ADDENDUM NO. 3

ORANGE BEACH HIGH SCHOOL FIELD HOUSE CITY OF ORANGE BEACH

ADDENDUM NO. THREE (3) – DATED JANUARY 18, 2021

JOB NO.:
DRAWN: JF
CHECKED: JHR
DATE: 11.16.2020
REVISION:
PROPOSED WATERLINE CHANGES 1-19-21
SCALE: 1"=20'
SHEET NO.:
C5.0
UTILITY PLAN

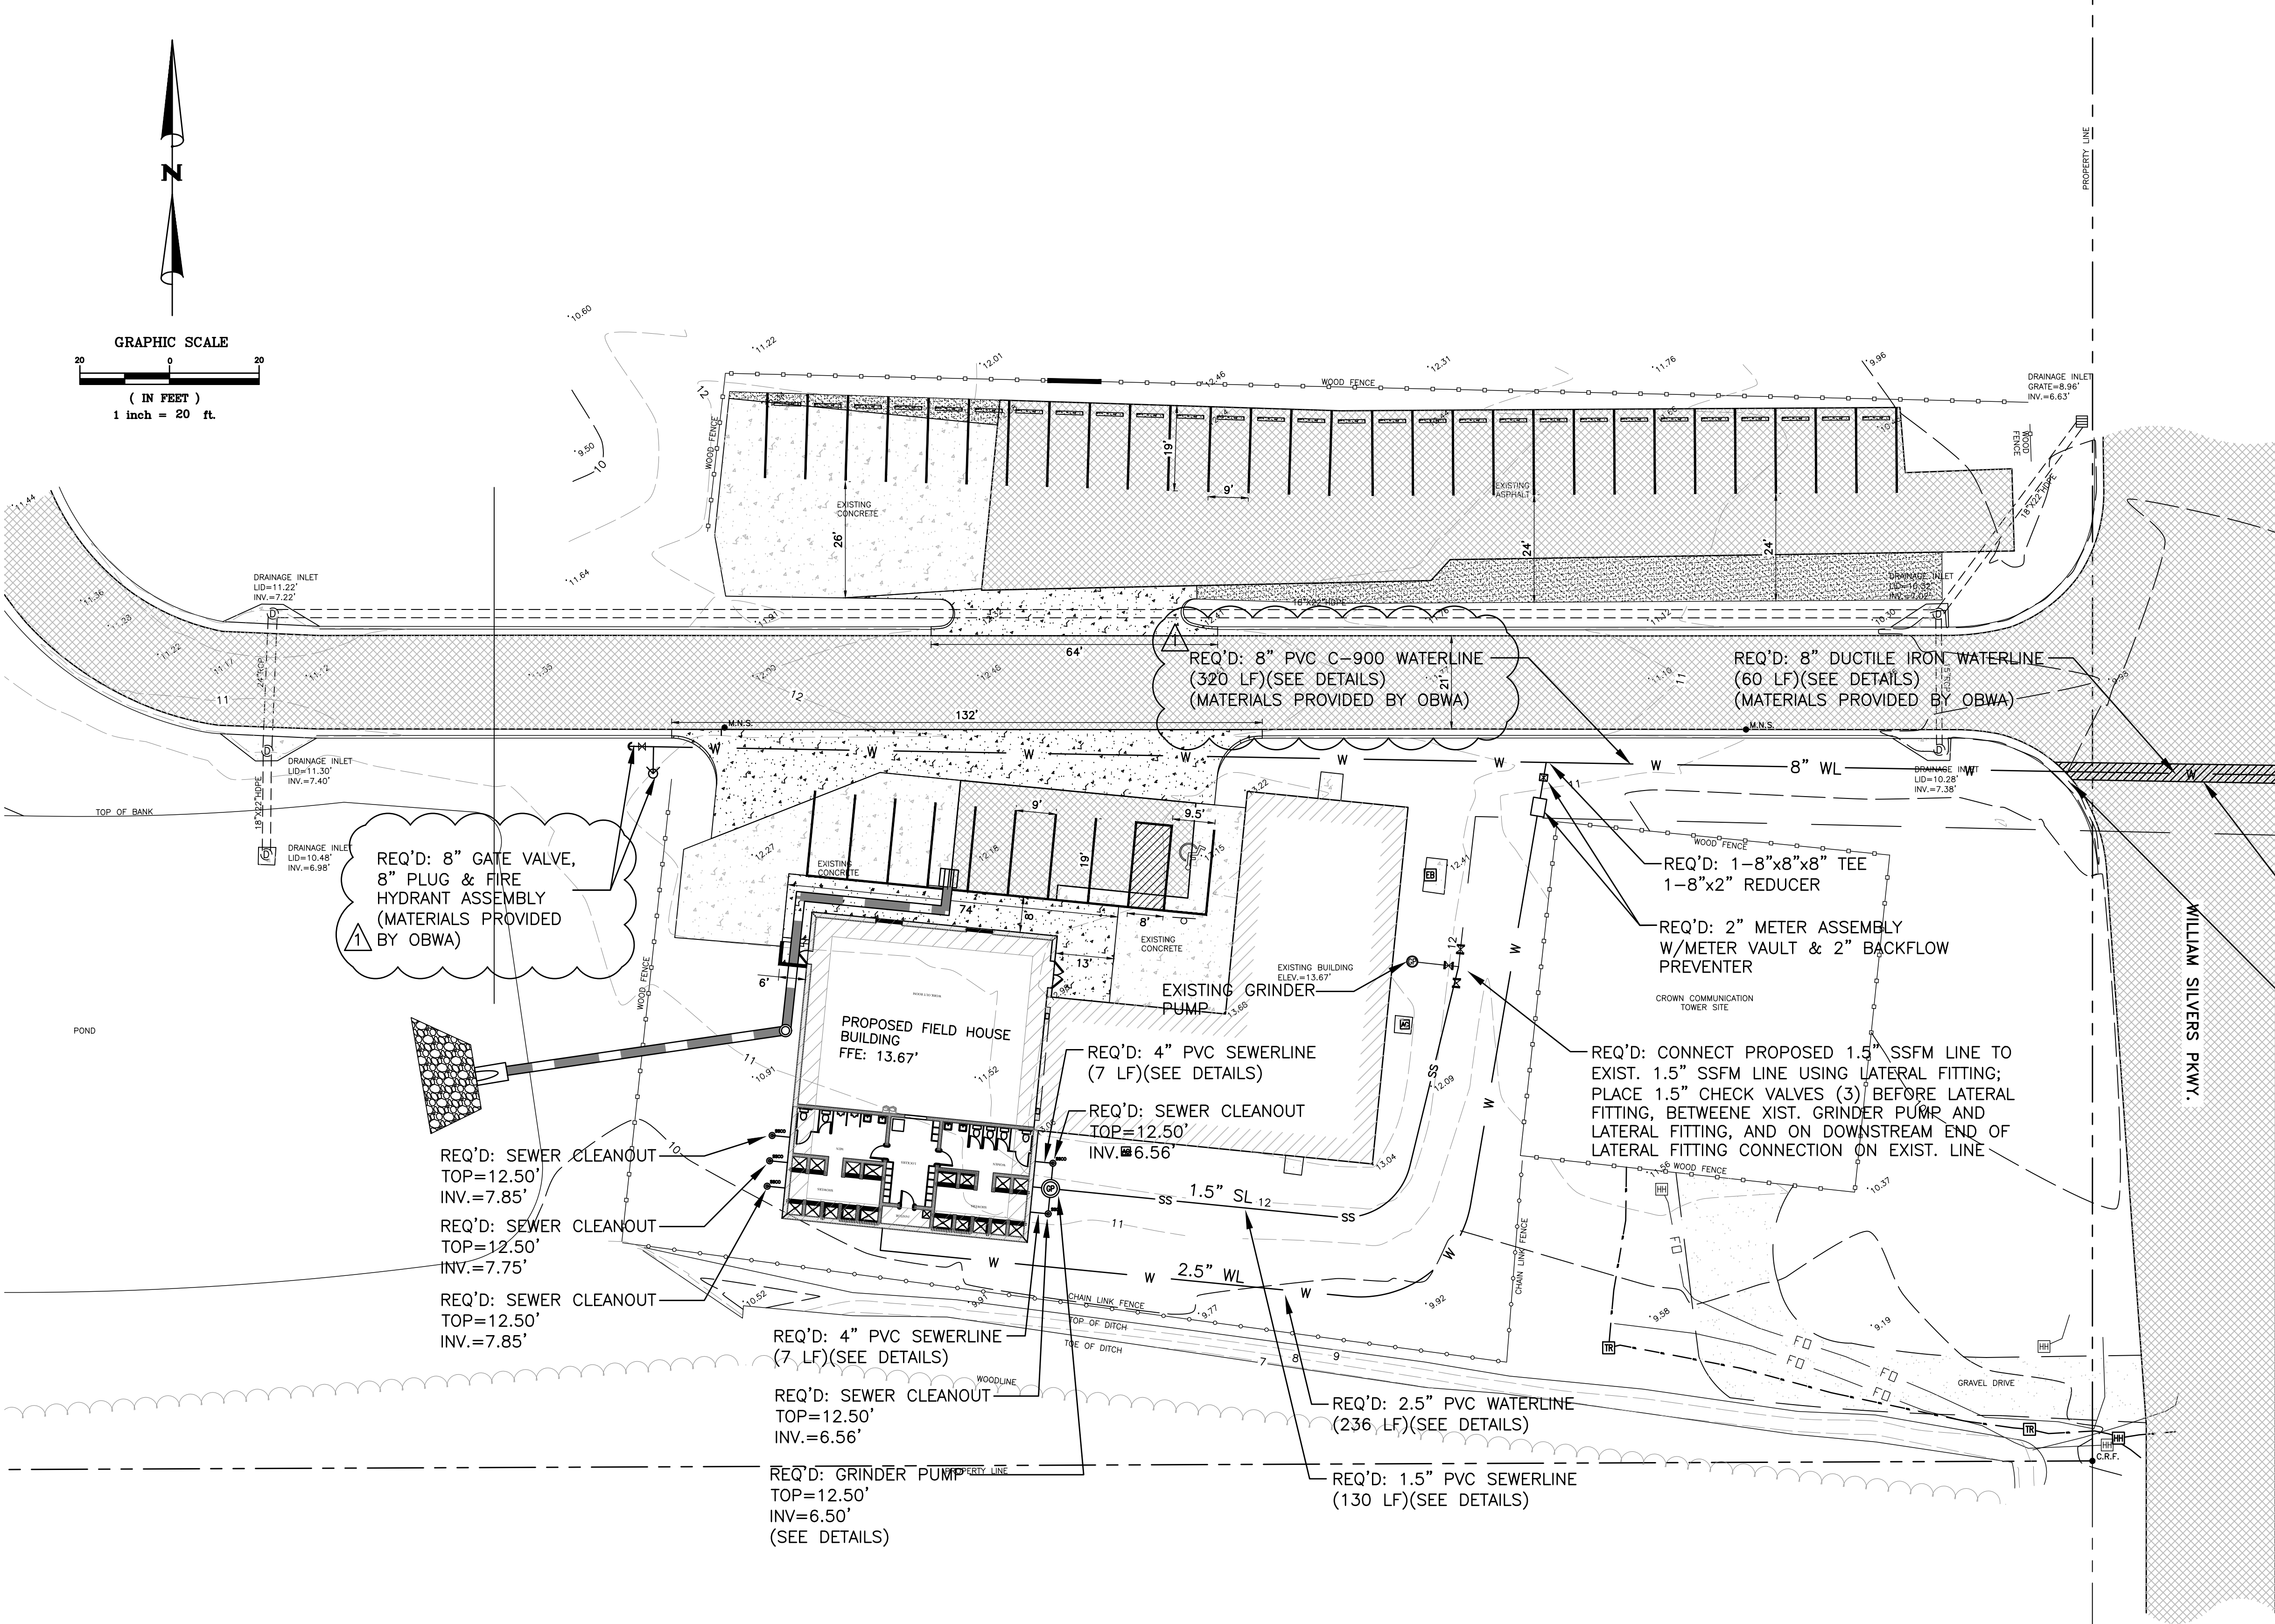
This Drawing has been replaced with the attached C5. OBWA informed us that the proposed 8” waterline needs to be extended to the western side of the building frontage so a future connection to the school would be easier and add a hydrant. They are providing the materials for these as before in the previous plan, and the contractor will provide labor. The contractor will also have to hydrostatic test the new 8” waterline, however, OBWA will provide the bacteriological testing for this.

REQ'D: THE CONTRACTOR SHALL PERFORM HYDROSTATIC TESTING (PER OBWA SPECS) FOR THE PROPOSED 8" WATERLINE. OBWA WILL PERFORM BACTERIOLOGICAL TESTING FOR THIS LINE.
